SUBJECT: FORT CALHOUN STATION - NRC SPECIAL INSPECTION
REPORT 05000285/2007006

IR 05000285/2007006; 02/20-04/09/2007; Fort Calhoun Station, Special inspection to evaluate ABB circuit breaker failures.

Figure 1 - Failed Mechanism Operated Contact Linkage Arm

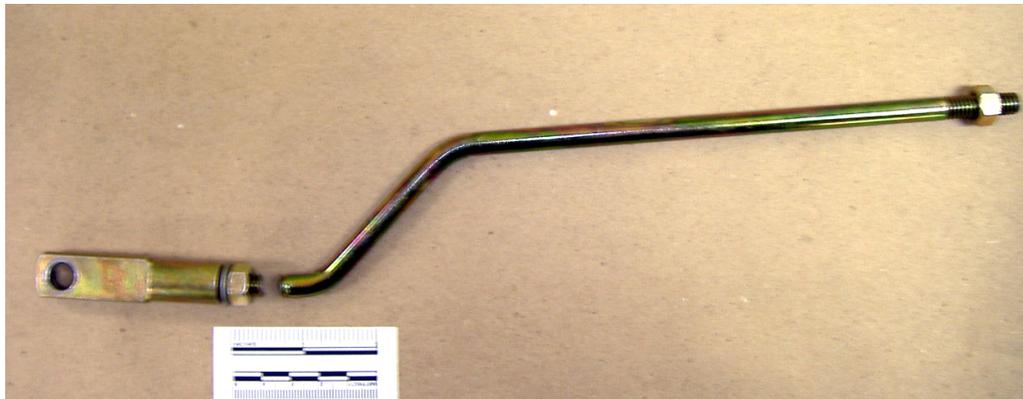
The team concluded that the January 25 and February 8, 2007, raw water pump breaker failures were due to inadequate design of the mechanism operated contact switch linkage arm used to adapt the ABB circuit breakers to the General Electric cubicles during the 1995 period. Both linkage arms failed at the same location (Figure 1) due to reverse bending fatigue. The number of operating cycles on the failed breakers were 1222 cycles, for raw water Pump AC-10B, and 1728 cycles for raw water Pump AC-10C. Replacement arms, manufactured to the same design specifications, also failed during laboratory testing due to reverse bending fatigue. The replacement arms, however, underwent additional stress cycles prior to failure. The inspectors concluded that the failure could have been predicted based on the linkage arm geometry, the static and cyclic stress induced on the component by the breaker and mechanism operated contact switch spring, and material used in the construction.

Figure 2 - Linkage Arm Installed in Modified 4160 Volt Breaker

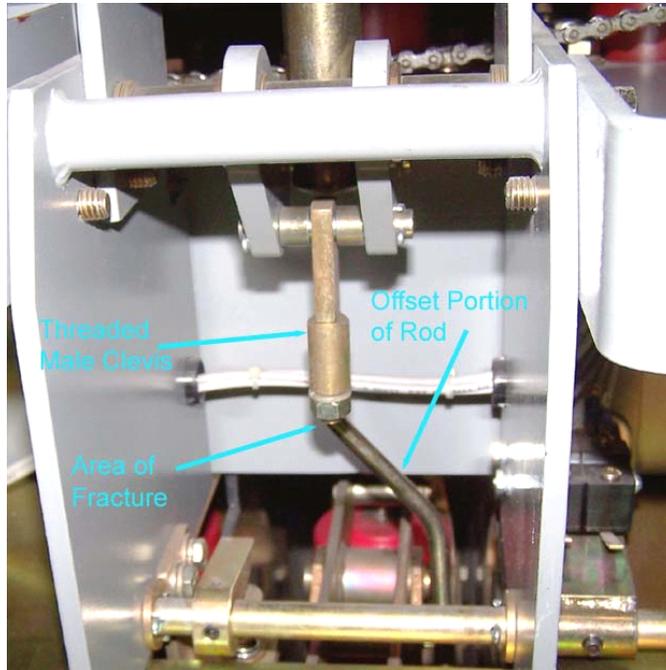
The mechanism operated contact switch is aligned with the breaker by a mechanical linkage arm and changes position as the breaker either opens or closes. The mechanism operated contact switch is located in the breaker cubicle and is not physically part of the breaker (Figure 2). The broken linkage arms resulted in failure of the raw water pump discharge valves to open during the pump starting sequence on January 25 and February 8, 2007. The normally-closed discharge valve receives an open signal after the pump breaker closes. The valve open-signal is generated when the mechanism operated contact switch changes position. The broken linkage arm resulted in the failure to complete the circuit.
